ADDENDUM #2 TO BID #21-029

BID NUMBER: 21-029

PROCUREMENT FOR: Waverly Park

TRENCH DRAIN SECTION
(REVISED DETAIL SHEET C305)

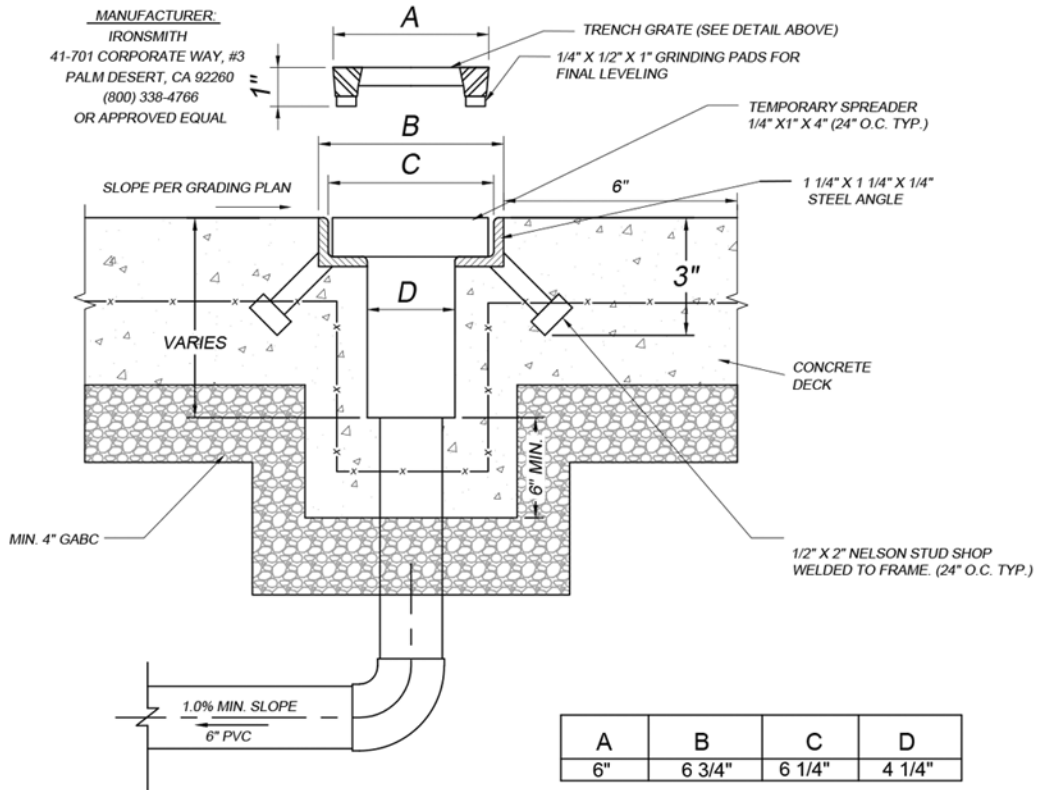
Question #28: On sheet C-305, the detail for the trench drain shows a concrete deck around it, however, the plans do not show any concrete around the trench drain. Can you provide a detail of how it will need to be installed per plans?

Response: Please see attached “Addendum 2 Drawing B” for revised detail.

1/2" x 1" x 1/4" THICK GRINDING PADS FOR
LEVELING - TYP. 4 OR MORE PLACES

MANUFACTURER:
IRONSMITH
41-701 CORPORATE WAY, #3
PALM DESERT, CA 92260
(800) 338-4766
OR APPROVED EQUAL

MODEL	DIMENSIONS	
	GRATE WIDTH	TRENCH WIDTH
M9059-6	6"	4-1/4"
